Document name: 210687-EDGE-XX-XX-CO-C-0001_LLFA RESPONSE[P05]

06 January 2026

Re: Salesbury View, Wilpshire – Application 3/2025/0801 LLFA consultation

GREENFIELD RUNOFF RATE

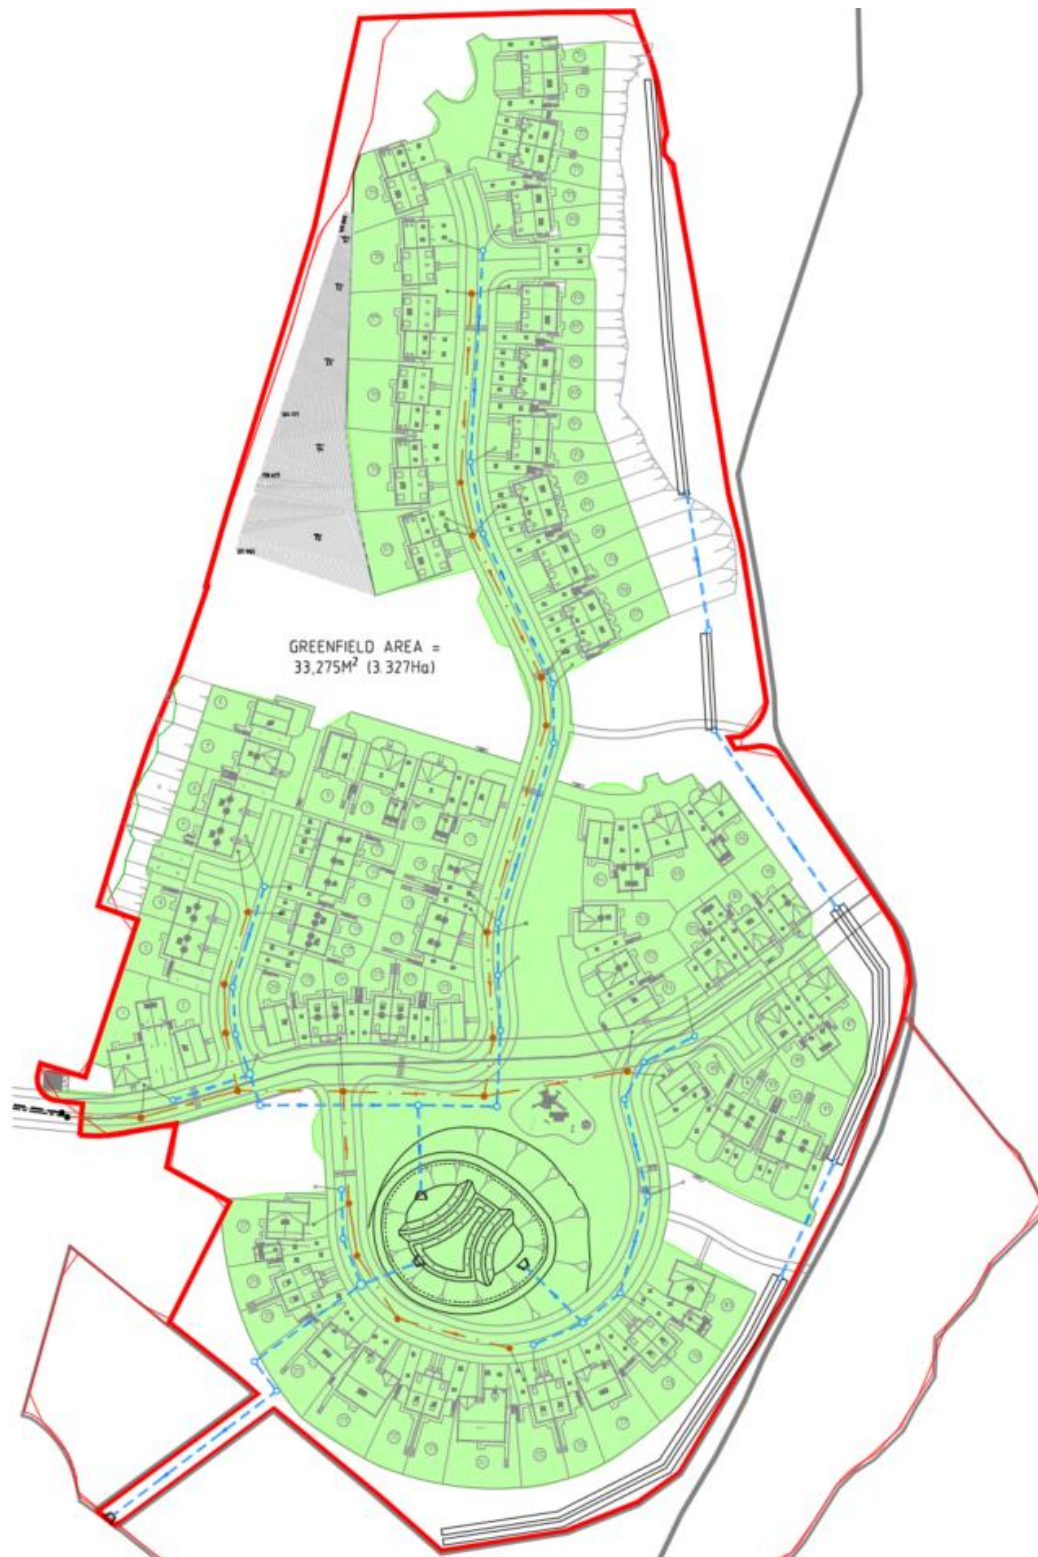
The LLFA note *“Standard 3 requires that the entire development area that could potentially drain to the proposed surface water drainage system in an extreme event shall be used for estimating greenfield runoff rates and volumes (including both permeable and impermeable surfaces).”*

As such the area used to calculate the greenfield rate is represented in the image below and totals 33,275M²

The greenfield runoff tool from HR Wallingfords UK Suds website has been used to determine the greenfield rate associated with this area. A QBAR rate of 28.9 litres per second is generated and will be the maximum allowable discharge rate for the site.

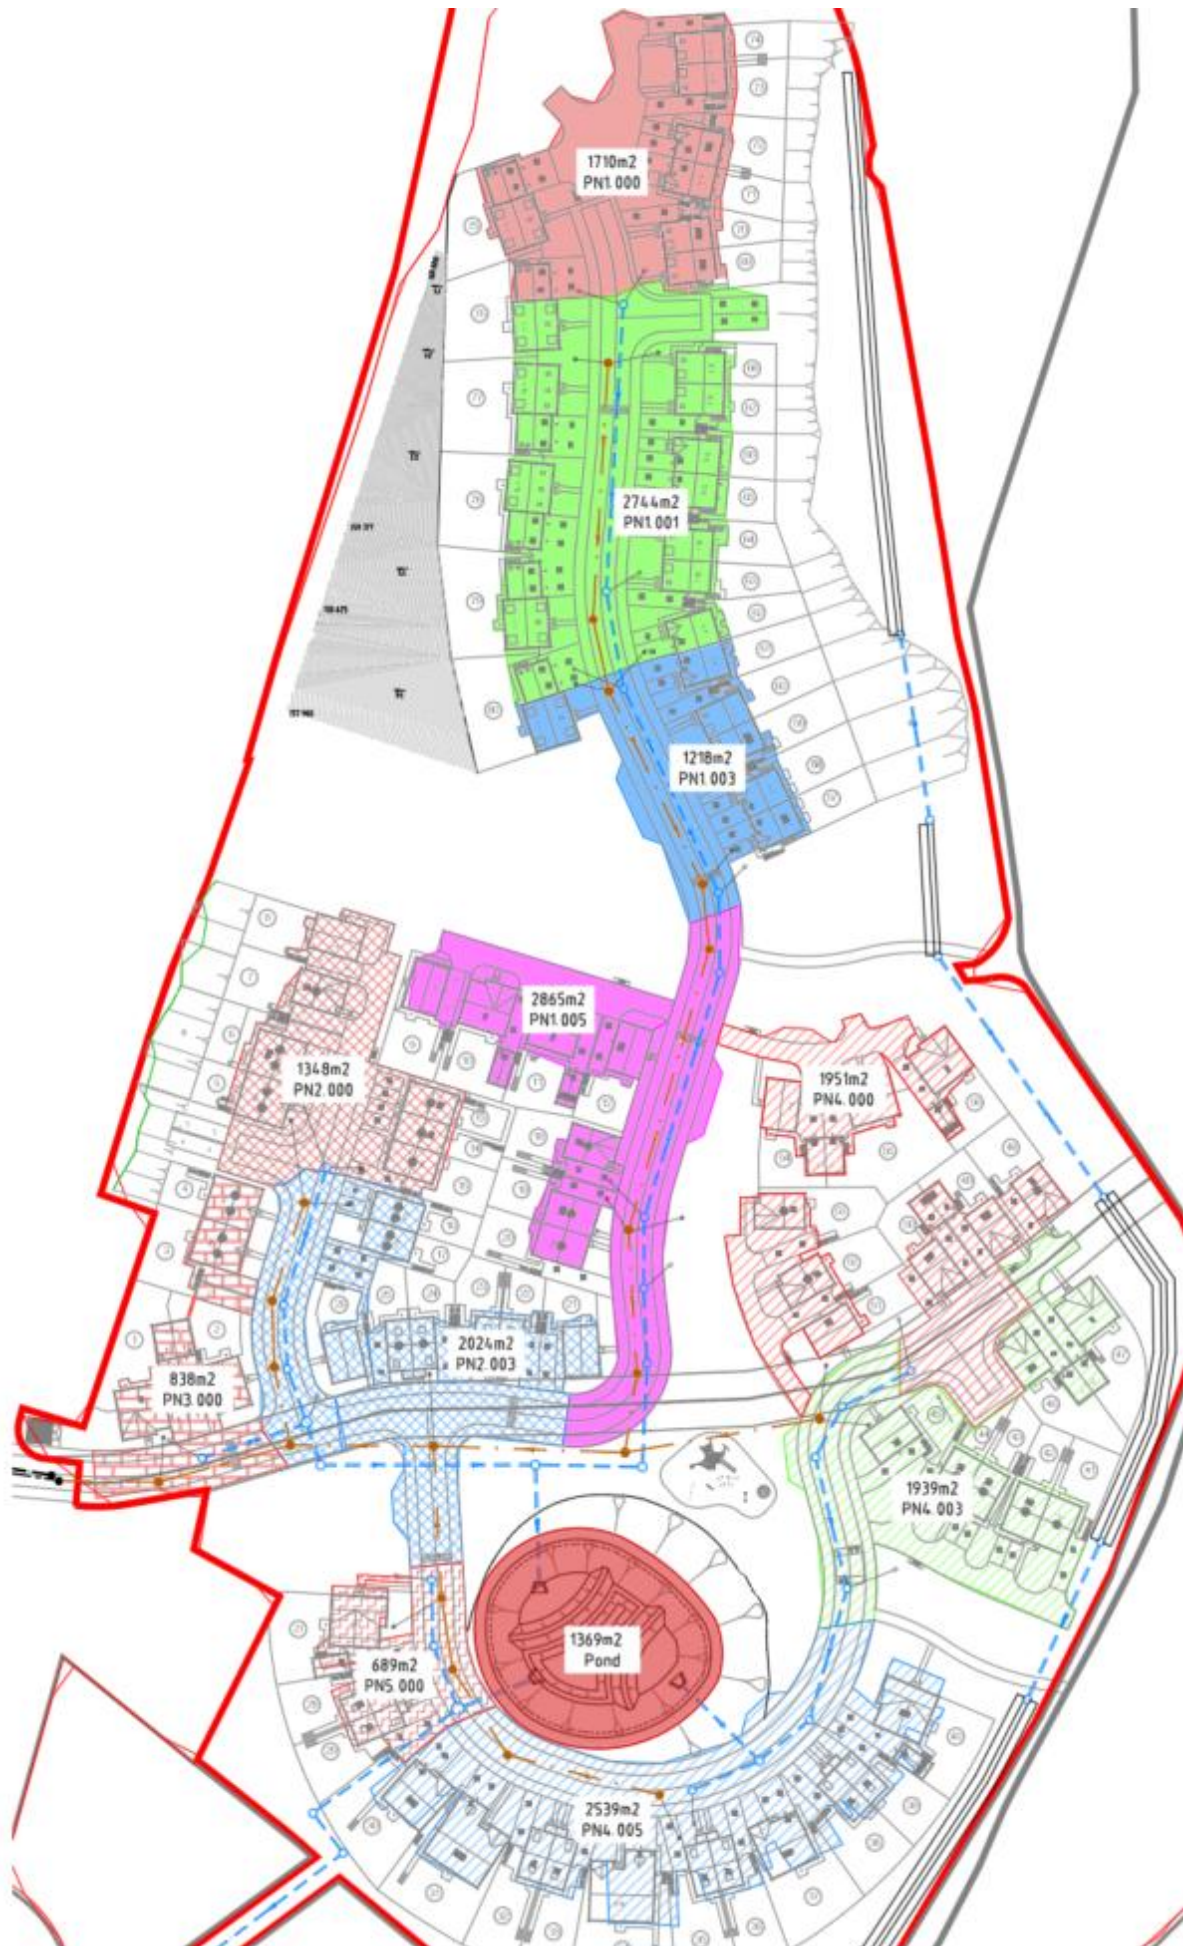
The LLFA notes “areas, such as gardens, roadside verges and areas of public open space, may not be positively drained, they may contribute indirectly to the drainage system during extreme events. The applicant must design their SuDS with an appropriate estimation of the area contributing to the drainage system, both permeable and impermeable”

The schematic catchment plan was provided previously to show the extent of areas contributing to the proposed drainage system. However, it did not include the SUDs basin as a contributing area. This has now been remedied, and the proposed contributing area is shown in the image below.

The areas total 19,524m² or 1.952Ha. With an additional area for urban creep included (10%) the total contributing area for the site equates to 21,476m² or 2.147Ha.

Ciria C753 (extracted below) notes an acceptable and conservative approach (for standard developments (with impermeability ratios of 50–65%)) is to use 100% runoff from impermeable areas and 0% runoff from pervious areas.

From the aforementioned site area measurements we can see that the site has 58% impermeability ratio (contributing area against greenfield area), so the approach taken on the drainage design and storage estimation is regarded as highly conservative. Moreover, the design does not yet consider the source control benefits and reduction in runoff rates and volumes from the proposed permeable paving, rain gardens and water butts with the storage volumes stated accommodating the full extent of assumed site runoff.
